**Response to Request for Additional Information – ANP-10287P**  
**“Incore Trip Setpoint and Transient Methodology for U.S. EPR Topical Report”**  
**(TAC No. Q00013)**

Figure RAI 13-2: GKN1 Cycle 26 Map 32 Assembly F11 F<sub>dh</sub> Pin Axial Distributions

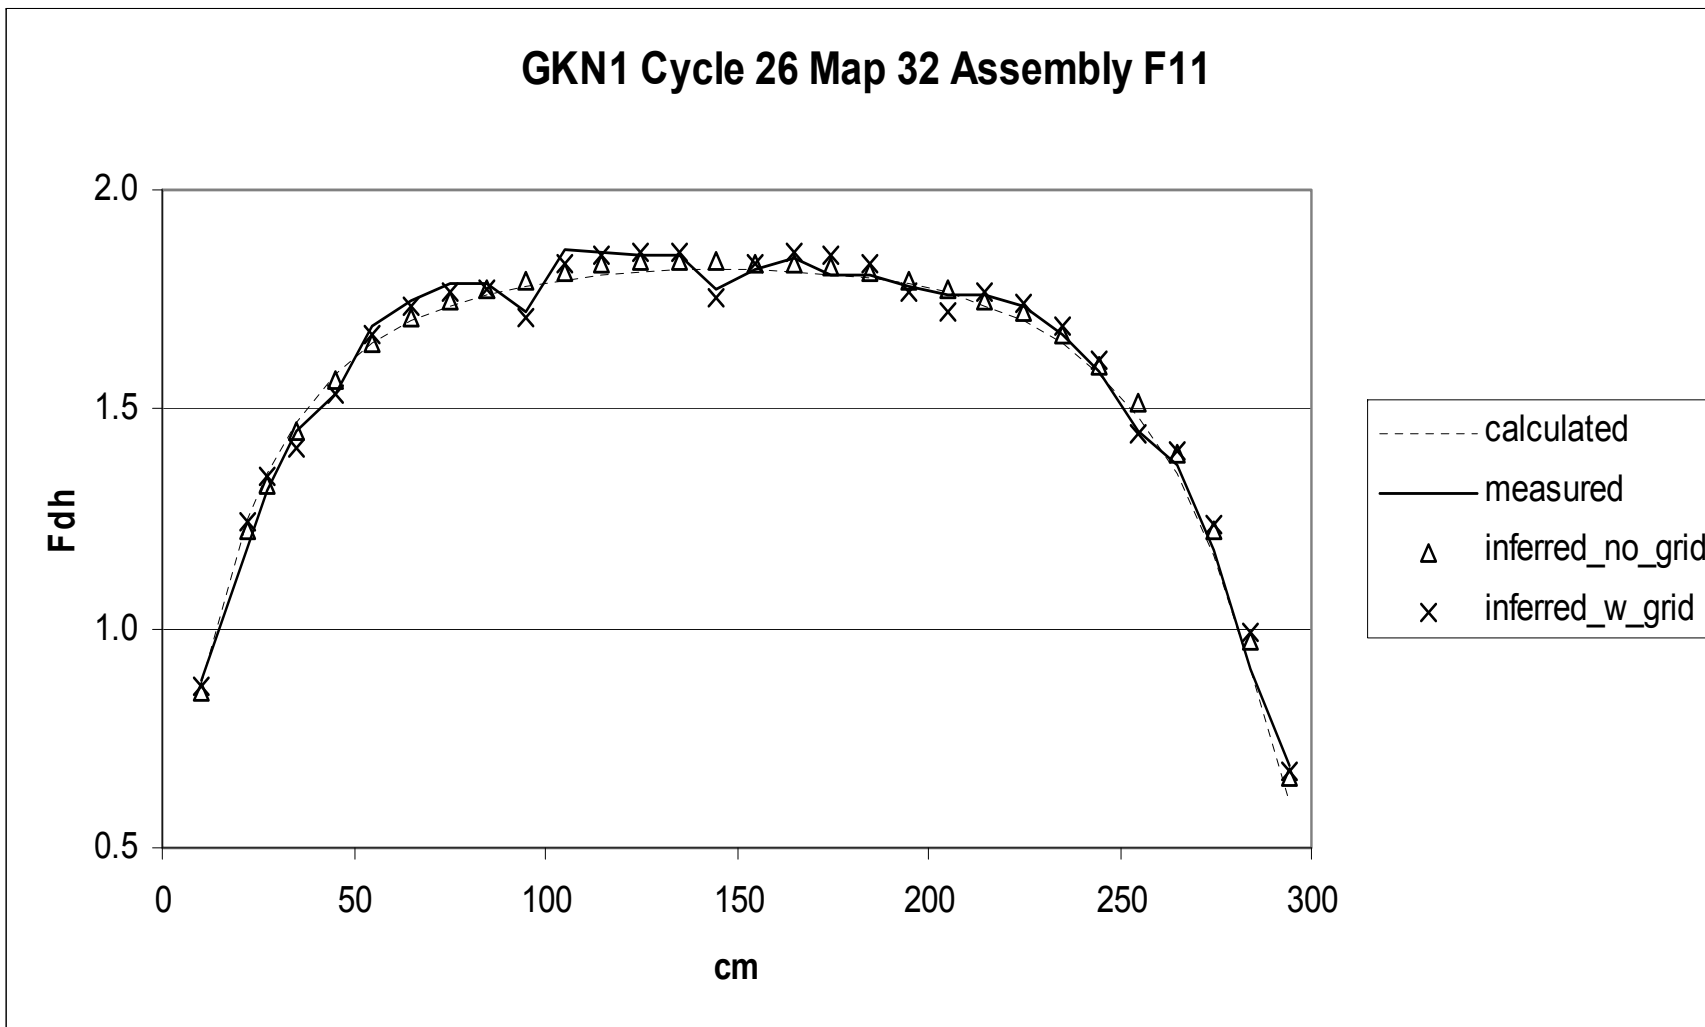
**RAI-13.** *Describe in physical terms the MEDIAN methodology used to extrapolate the adjusted fluxes to the non-measured nodes (Section E4 of ANP-10287). Provide an example calculation with the actual numbers for an AMS measurement.*

For this map, location F11 is an instrumented location. In addition to the MEDIAN calculation which generated the data in Figure RAI 13-1, an additional MEDIAN calculation was performed where the measured data for location F11 was removed (i.e., the location F11 distribution is generated using the MEDIAN extrapolation methodology). As a result of these 2 sets of calculations the following  $F_{dh}$  pin axial distributions for location F11 are available:

Table RAI 13-1 and Figure RAI 13-2 summarize the results obtained from these calculations.

Figure RAI 14-2: GKN2 Assembly Type 1 Conversion Factor Sensitivity to Instrumented Location

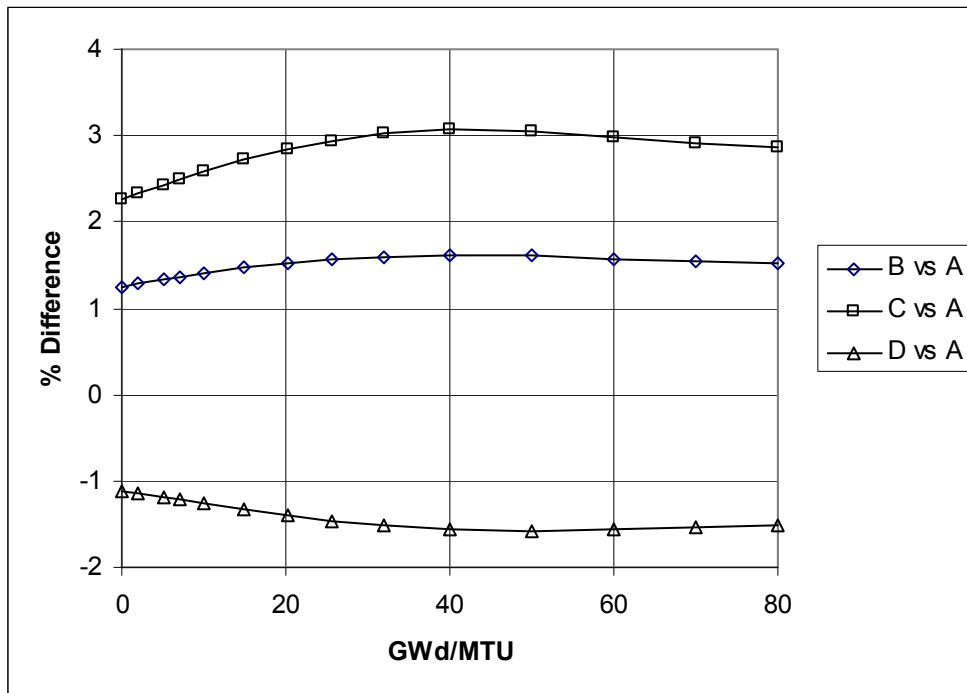
**RAI-14.** *Provide measured data to support local peaking factor uncertainty discussed in Section E.7.4 of ANP-10287 over the relevant range of exposures where a fuel pin would be limiting.*

- The first assembly type was a non-gad assembly with 3.80 without U235 enrichment. The percent differences between the calibration factor results are presented in Figure RAI 14-2.
- The second assembly was a gad assembly with 3.80 without U235 enrichment and twelve pins of seven without gad at 2.60 without U235 enrichment. The gad rod locations are shown in Figure RAI 14-1. For locations C and D in the gad assembly, gad rods are located diagonally adjacent to the instrumented location. The results are presented in Figure RAI 14-3.

Figure RAI 14-2 shows a spread of over 4% is observed for the non-gad assembly, and Figure RAI 14-3 shows a similar spread after the gadolinia burns out.
